**MONTGOMERY COUNTY PLANNING DEPARTMENT**  
THE MARYLAND-NATIONAL CAPITAL PARK AND PLANNING COMMISSION

MCPB  
Item # \_\_\_\_\_  
April 26, 2007

SUBJECT: Seven Locks Road Sidewalk and Bikeway: Phase I Facility Planning Study  
Project Prospectus Recommendations, Potomac Policy Area

Figure 2

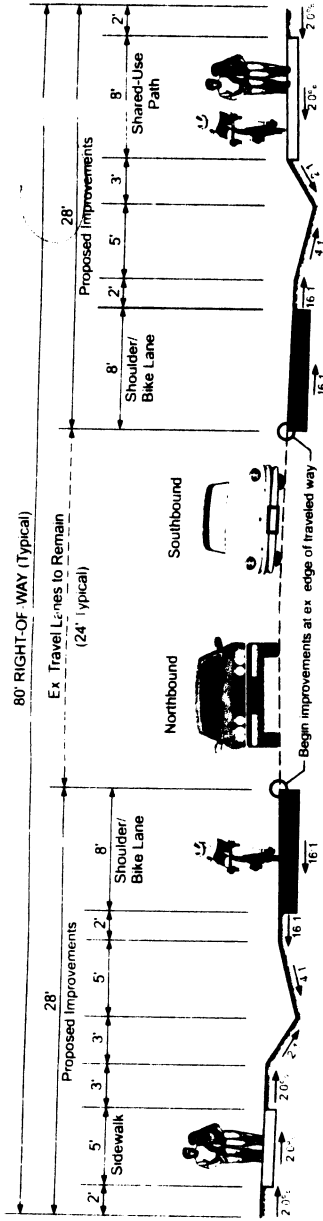
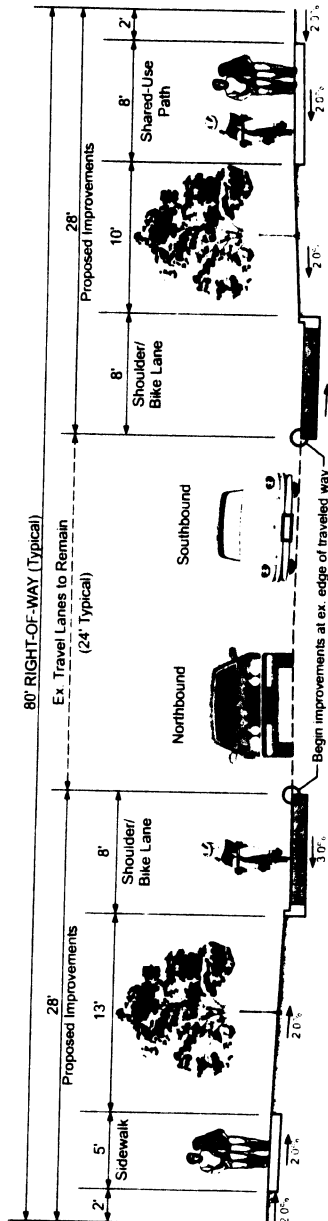
2. The Phase II design should revise the typical section to include two 11-foot wide travel lanes plus 5-foot wide bike lanes for a total roadway width of 32 feet, with no additional roadway shoulder width. On-street parking bays and bus stop pull-outs should be considered on an as-needed, site-specific basis.
3. To further reduce impacts without reducing transportation service, DPWT should consider using the typical section C for Station 108+00 to Station 109+00 and Station 126+00 to Station 155+00.
4. During the Phase II Facility Planning Study, DPWT must submit a Natural Resources Inventory/Forest Stand Delineation (NRI/FSD) for approval. The NRI/FSD will determine whether a full forest conservation plan will be required.
5. During the Phase II Facility Planning Study, DPWT should confirm the need to obtain a park construction permit for any work resulting in park impacts.

We find that the Recommended Alternative typical roadway section is too wide, with the shoulders contributing six to eight feet of width that appear unnecessary. Eliminating three feet of shoulder space beyond the bike lanes would reduce the typical section for the project by six feet, without a similar reduction in transportation safety and service. If one foot of each travel lane is also eliminated, the resulting geometry – 5’/11’/11’/5’, would match the geometry currently being considered by the County Council’s Transportation and Environment Committee as part of Council Bill 48-06 and ZTA 06-04. Reducing the needed ROW width by up to 8 feet would have a number of benefits, including reduced property impacts, grading, forest impact and wetland encroachment along the two-mile segment of road. Staff estimates that the reduced section would also reduce the amount of impervious roadway surface by approximately two acres. Capital costs of the project would also be reduced, though estimates are not available at the time of writing. Therefore, we recommend that **Phase II should include design for a typical section with two 11-foot travel lanes plus 5-foot bike lanes for a total roadway width of 32 feet, with no additional roadway shoulder needed.**

**Figure 3**

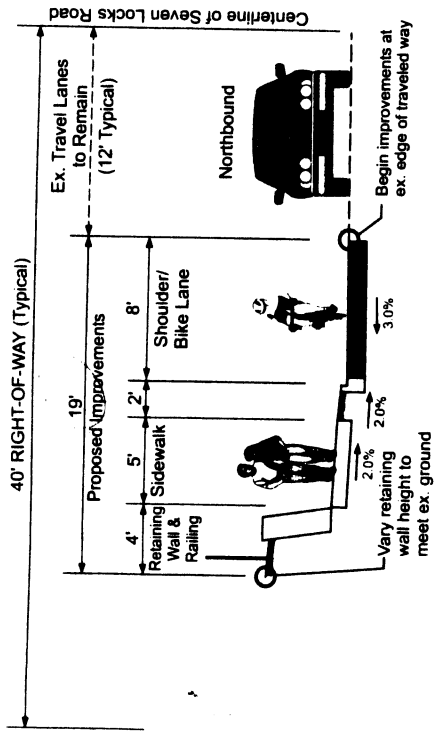
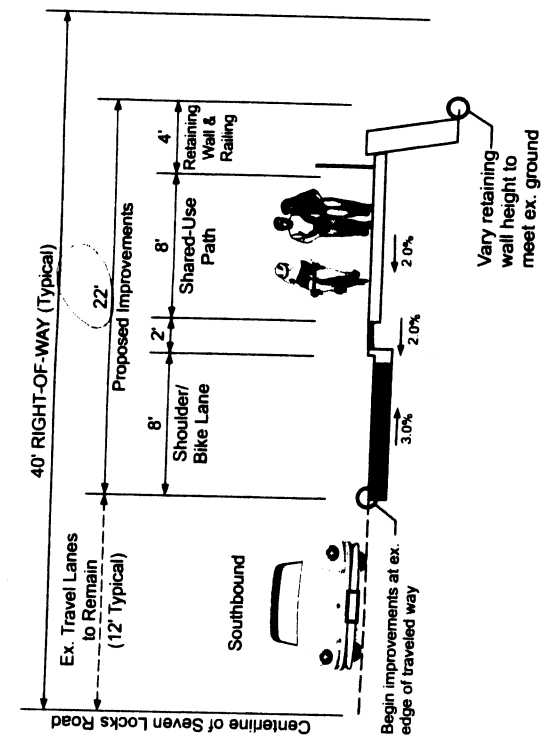
The Recommended Alternative includes the reduced typical sections (Sections C1 and C2 shown in Figure 3) at this location to reduce impacts, but does not avoid either resource. During Phase II, additional evaluation will be conducted to avoid or minimize impacts to the historic resource. **If impacts to the historic setting are confirmed during Phase II, then DPWT will need to seek a Historic Area Work Permit (HAWP) from the Historic Preservation Commission.**

In addition to the overall economy of reducing the ROW by eliminating the shoulders, **to further reduce impacts in Phase II, DPWT Facility Planning should investigate a reduced cross-section between Station 108+00 to 109+00 and Station 126+00 to 155+00**, segments not currently recommended for the reduced sections (Sections C1 and C2). These are sections predominantly lacking land uses directly fronting the road.

- Station 108+00 to 109+00 - To reduce wetlands impact south of Ivymount Terrace.
- Station 126+00 to Station 155+00 - To reduce impacts to the historic resource of the Scotland AME Zion Church; waterway/creek alignment of Snakeden Branch; and wetlands, slope and floodplain impacts between Tuckerman Lane and Bells Mill Road.
